Quality Control Check Report. Stage: After Finishing Stage III (Apartments)

Flat No	A-105	Other	Sl. No	38682
Company	AMPAL (P) LTD	Project	Phase	
Prepared by	P. Raghav	Sign	Date	29-10-20
Project Manager	Rampasad	Sign	Date	29-10-20
Previous stage report no.	37631	Report filed and signed by PM	☒ Yes ☐ No	
Checked By MD on	MD Sign	For filling	☐ Yes ☐ No	
Recommendation: ☐ Stop further work. Submit ATR on QC report to QC team. Proceed only after recheck by QC. ☐ Stop further work. Proceed with work after submitting ATR on QC report to QC team. ☒ Proceed with further work only after making corrections pointed out in the QC report. ATR not required. ☐ Proceed with further work. ATR not required.

GULMOHAR RESIDENCY

Details of Additions & Alterations

A-BLOCK-FLAT NO 5-SPLIT WORKING PLAN-1360 sft	Direction Owners & Developers : Modi Realty Mallapur LLP Project Name & Phase : Gulmohar Residency
Description	Date : 01.06.2020 Prepared By : Jayapradha Approved By : Soham Modi Scale : N.T.S Modi Properties Pvt Ltd Phone: +91-40-66335551

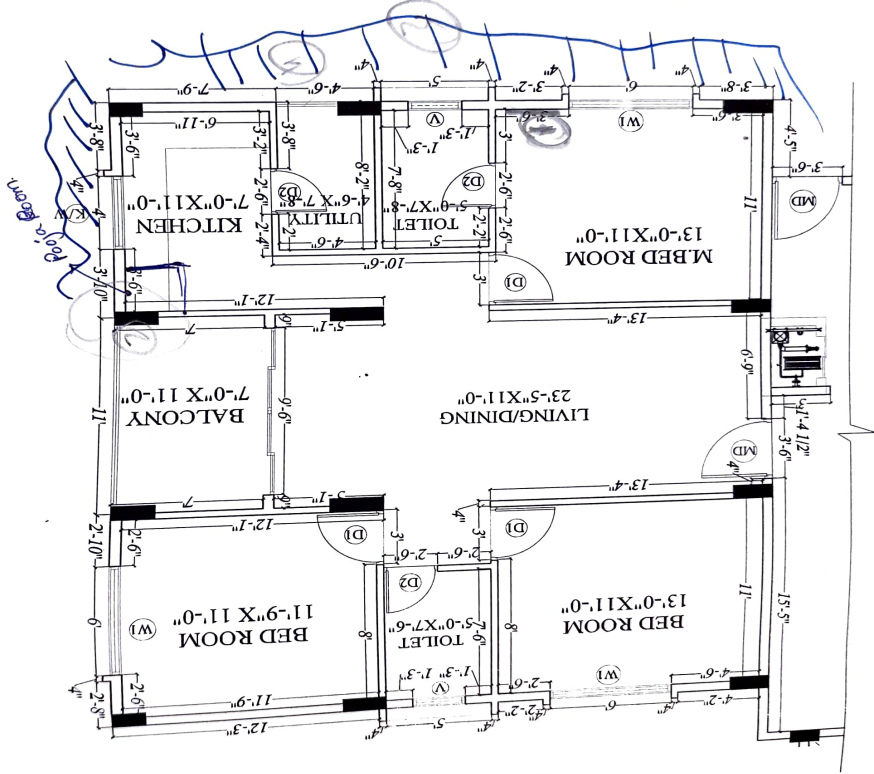
I hereby confirm that I have given the details of the minor additions and alterations that are required in the above referred flat in the pages attached herein. Please complete the changes suggested by me. I agree to pay the charges, if any, for the additions and alterations that I have asked you to make, as per the rates suggested by you. I shall deliver all the materials that are required to be provided by me at the site on or before _____. In case I fail to deliver these items to the site by the specified date, you may complete the works in the flat as per the standard items provided by you.
